ERRATA SHEET

EXAMPLE 1

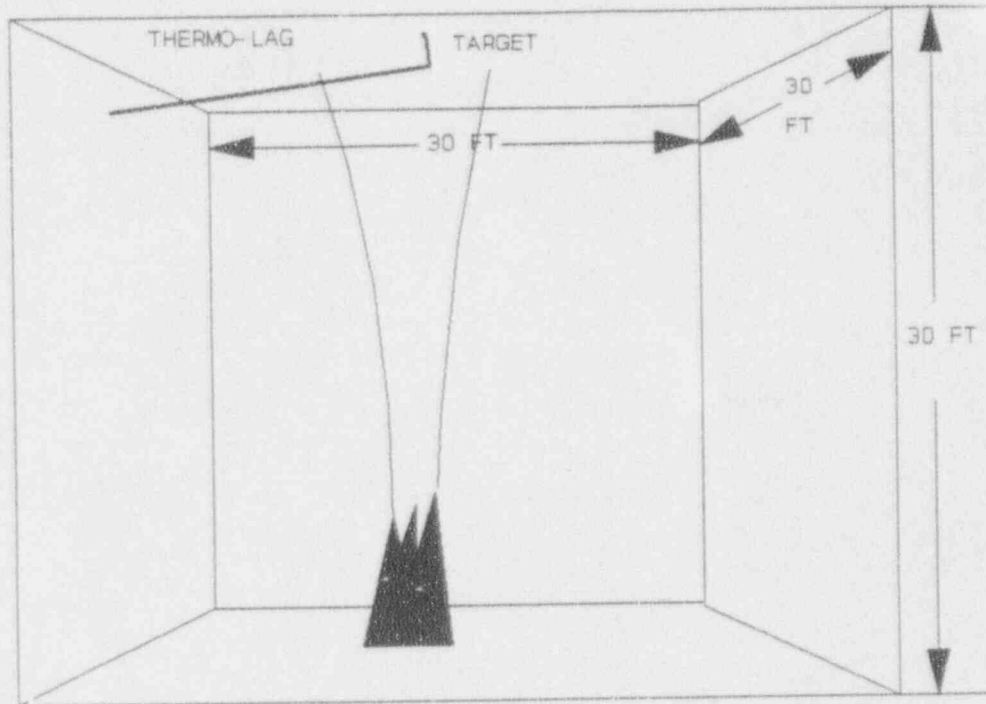
Example 1:	add: Thermo-lag "(lhr)"	Clarification
	Fire size confined to 12.25 ft ²	Clarification
	Fire located in center of room	Clarification

EXAMPLE 2

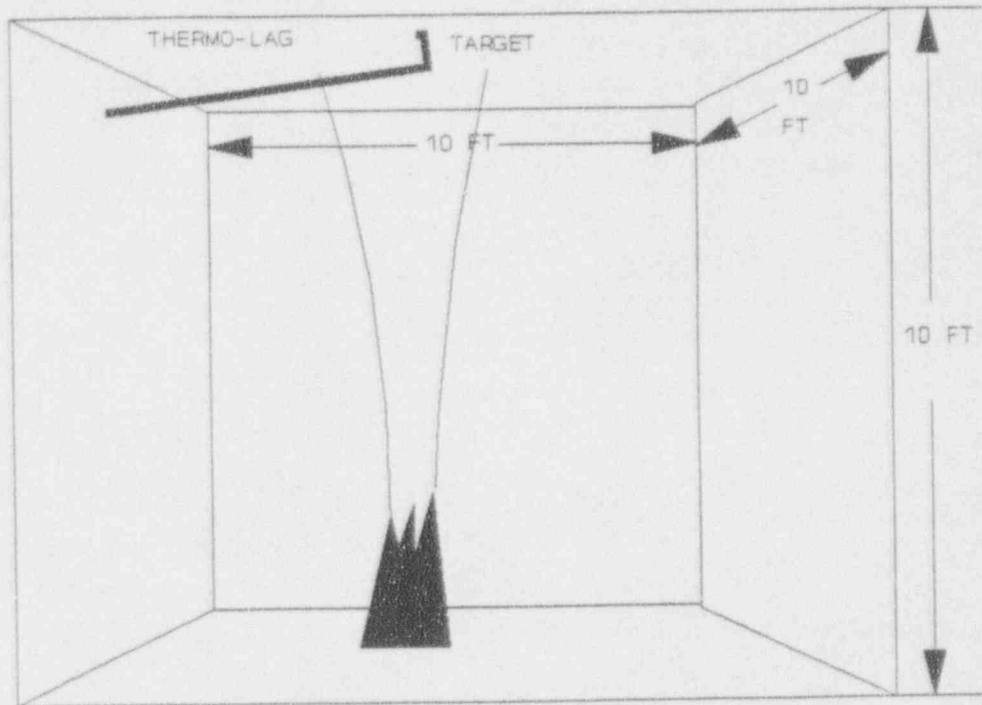
Example 2:	add: Thermo-lag "(lhr)"	Clarification
	Fire size confined to 12.25 ft ²	Clarification
	Fire located in center of room	Clarification

ATTACHMENT 2
EXAMPLE 3
THERMO-LAG OUTSIDE OF FIRE PLUME

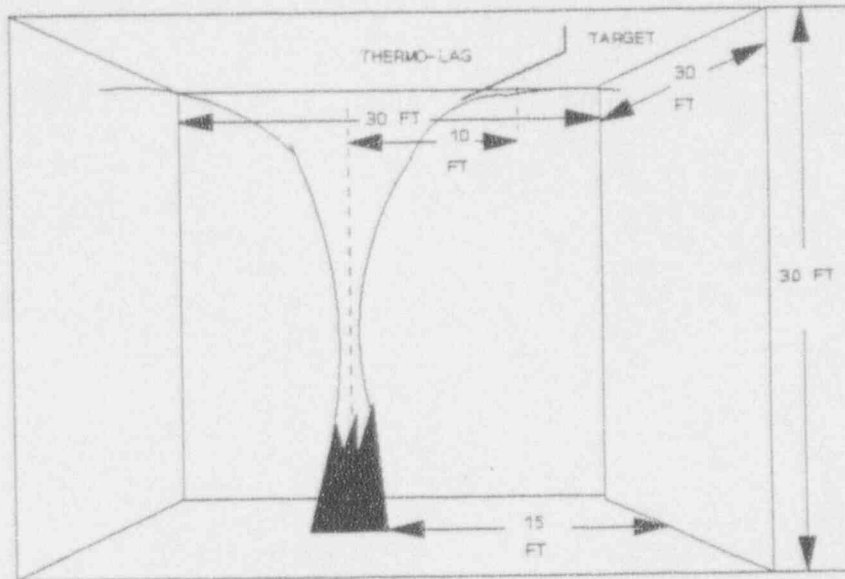
Example 3: add: Thermo-lag "(1hr)"
Fire size confined to 12.25 ft²

EXAMPLE 4

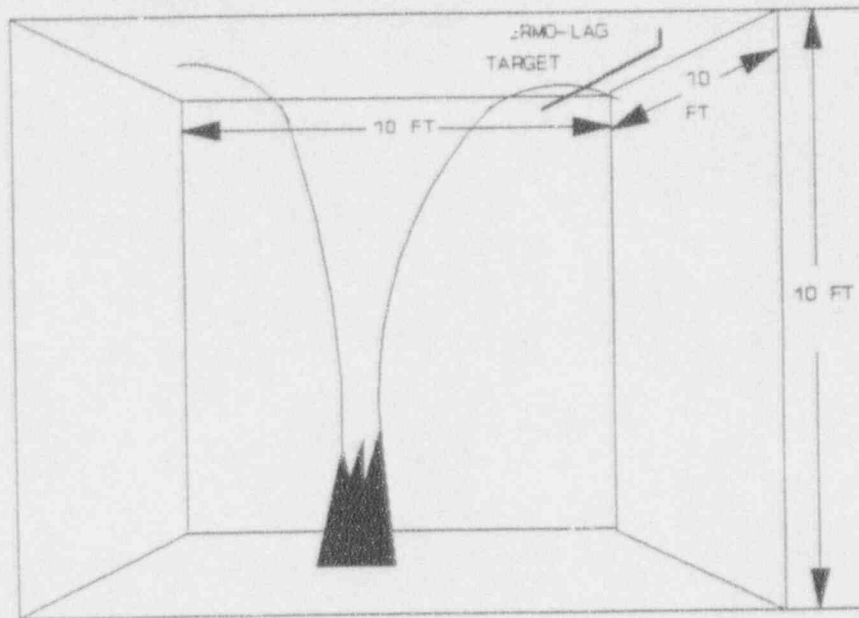
Example 4: add: Thermo-lag "(1hr)"	Clarification
Fire size confined to 12.25 ft ²	Clarification
Fire located in center of room	Clarification

EXAMPLE 5

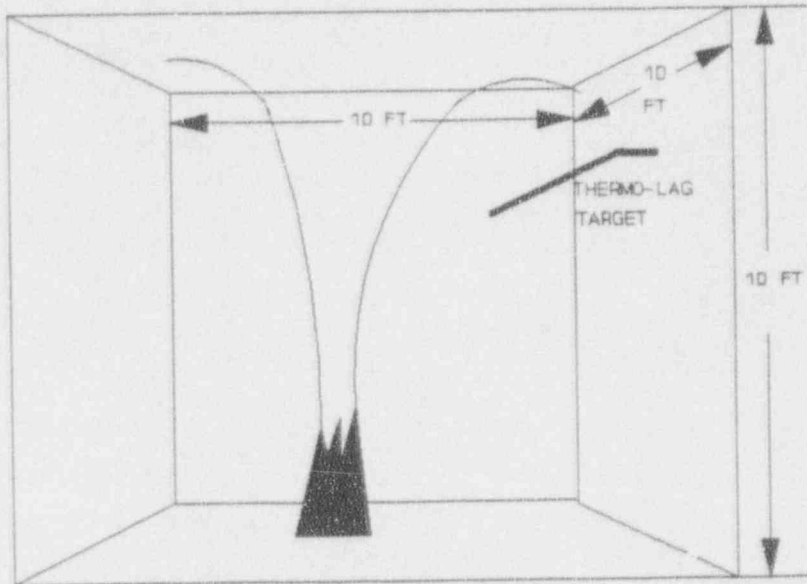
Example 5: add: Thermo-lag "(1hr)"	Clarification
Fire size confined to 12.25 ft ²	Clarification
Fire located in center of room	Clarification
